Subject: **Response to Portion of NRC Request for Additional Information
Letter No. 388 Related to ESBWR Design Certification Application –
Control Room Habitability – RAI Numbers 9.4-29 S04 and 9.4-57**

**Response to Portion of NRC Request for
Additional Information Letter No. 388
Related to ESBWR Design Certification Application**

Control Room Habitability

RAI Numbers 9.4-29 S04 and 9.4-57

Figure 6.4-2, Control Room Habitability Area Airflows Emergency Operation - FOR ILLUSTRATIVE PURPOSES ONLY

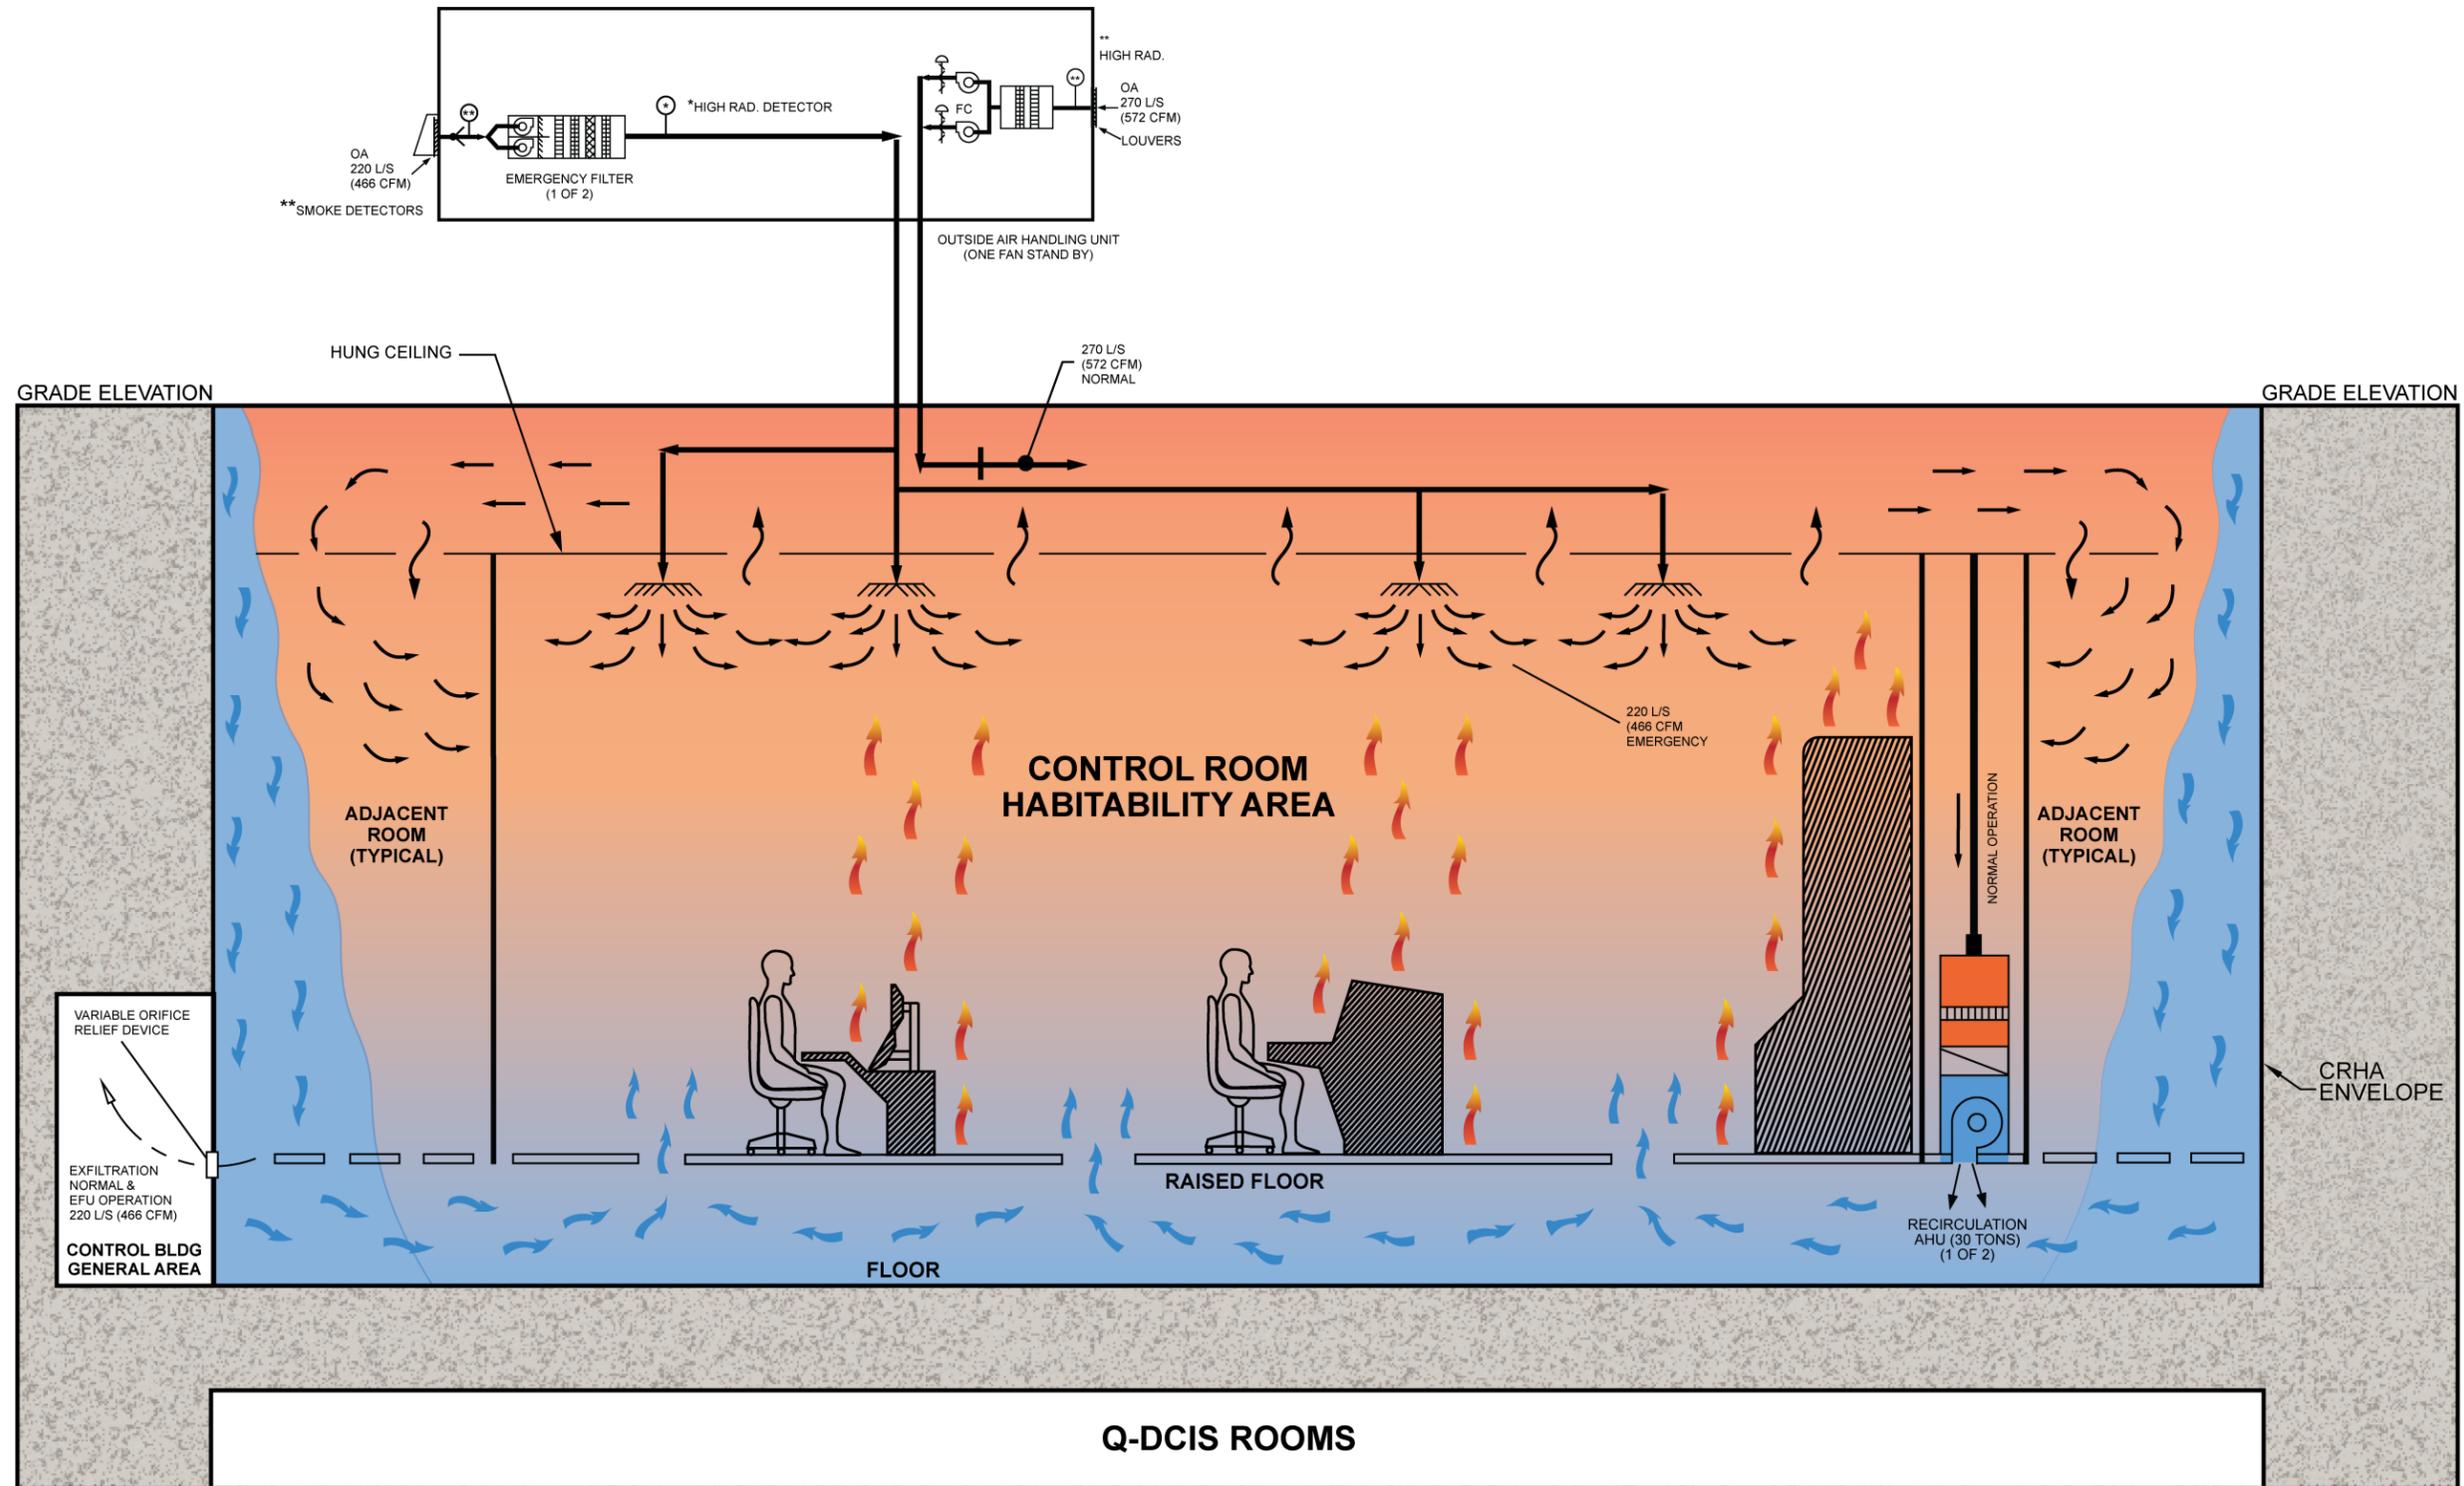
- a. Add Enclosure 1 of MFN 09-380 "Figure 9.4-29 S3-2, Control Room Habitability Areas Airflows Emergency Operation" or similar illustrative drawing of the design intent of airflows in the CRHA, to Tier 2 of the DCD. Illustrative drawings, which describe how mixing occurs, should be added to the DCD to capture the insights obtained from the GOTHIC analyses.*
- b. Describe requirements for emergency actions (i.e., when the EFU is providing ventilation to the CHRA) to promote convective currents and improve CRHA air quality, such as identifying specific doors to be shut in the CRHA.*
- c. Provide more specific discussion of any other design features or actions that will assure that the CRHA will be optimized to prevent short cycling and promote the development of convective air flows in the CRHA.*

- a. Add Enclosure 1 of MFN 09-380 "Figure 9.4-29 S3-2, Control Room Habitability Areas Airflows Emergency Operation" or similar illustrative drawing of the design intent of airflows in the CRHA, to Tier 2 of the DCD. Illustrative drawings, which describe how mixing occurs, should be added to the DCD to capture the insights obtained from the GOTHIC analyses.*

DCD Tier 2, Subsection 6.4.4, Emergency Mode, will be updated to include the RAI 9.4-29 S03 (Letter MFN 09-380, June 12, 2009) airflow and mixing discussion; and the CRHA Airflows Emergency Operation basic drawing will be added as a new figure to DCD Tier 2, Section 6.4.

New Figure 6.4-2, "Control Room Habitability Area Airflows Emergency Operation – FOR ILLUSTRATIVE PURPOSES ONLY" will be added to DCD Tier 2, Section 6.4.

The airflow developed in the ESBWR control room during worst case (outside air temp of 117°F) accident conditions when the CRHA is isolated and the EFU is in operation with passive cooling is as follows and is illustrated in Figure 6.4-2.
